Access Compliance Report

Public Rights-of-Way

Intersection ID: 53339	Main Street: NORTHLAKE CENTRE PY	Cross Street: CALHOUN ST	Location:	W
ADA ID: 3A3D4859022B	Ramp Type: BlendTrans1	Initial Pass/Fail: Fail	Overall Compliance: No	Severity Score: 8.75
Codes/Mitigation Info/Possible Solution		Field Measurements/Component Compliance

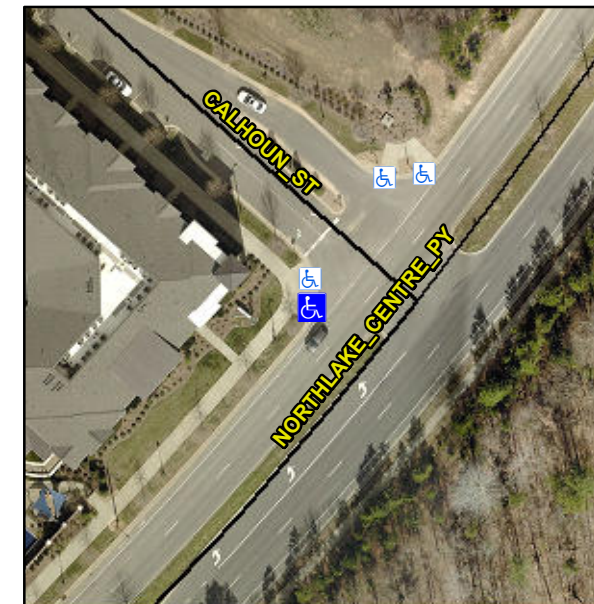
MEDIAN ACROSS NORTHLAKE CENTRE PY

R304.5.1

Remove & Replace Curb Ramp With Two New Directional Ramps or Equivalent.
